2014 - 2016 Corvette: Service Bulletin: #16-NA-170: Brake Pulsation and/or Vibration During Brake Apply

#16-NA-170: Brake Pulsation and/or Vibration During Brake Apply - (July 20, 2016)

Subject : Brake Pulsation and/or Vibration During Brake Apply

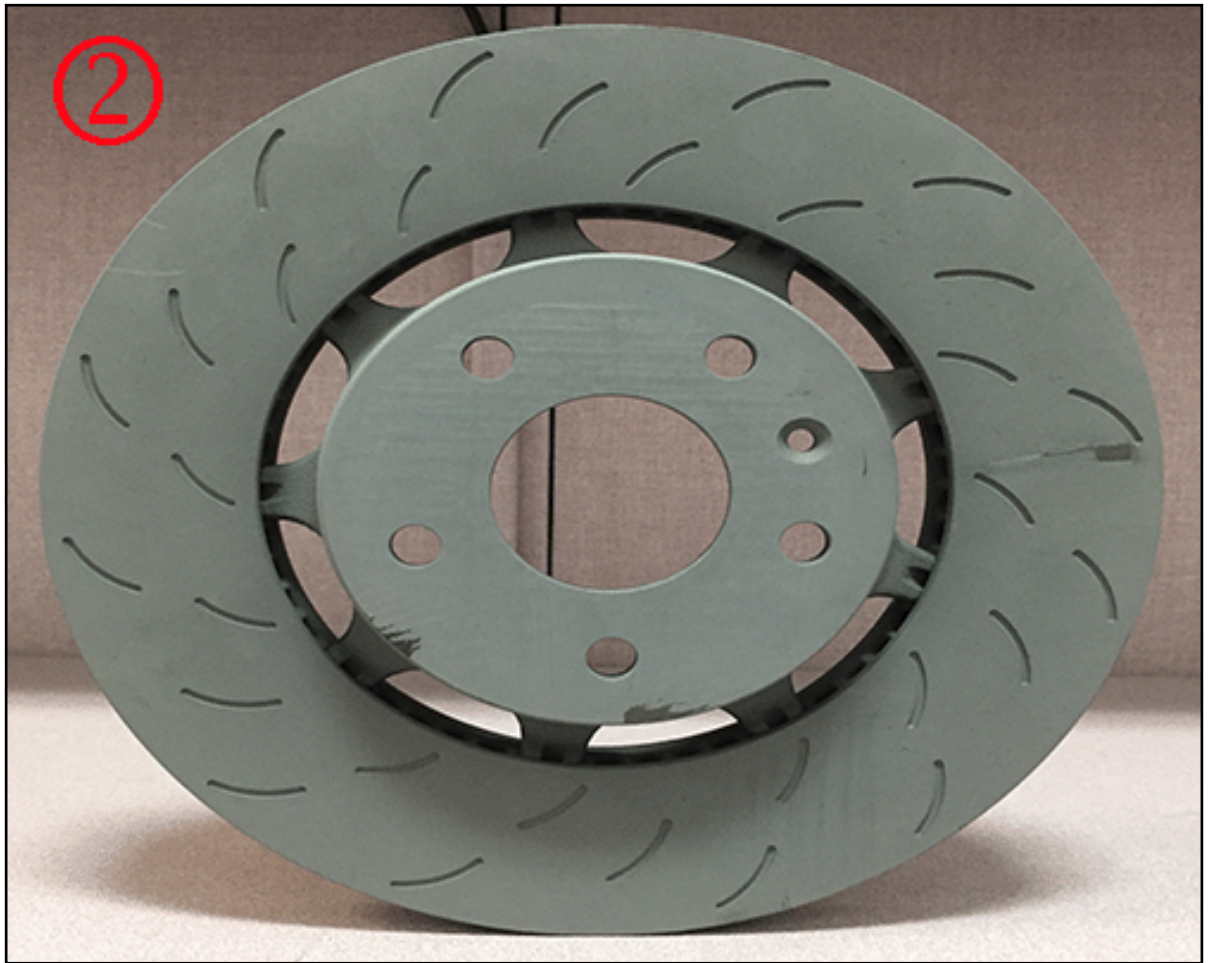
This condition may be due to excessive lateral runout (LRO) or interaction between the inner top hat section to the rotor ring.

- For front rotors and vehicles built prior to May 31, 2016, replace old two piece design (2) with new one piece design (1).
- For rear rotors and vehicles built prior to July 23, 2015, replace old two piece design (2) with new one piece design (1).

Important: The rotors *MUST* be replaced as a pair due to a design change.
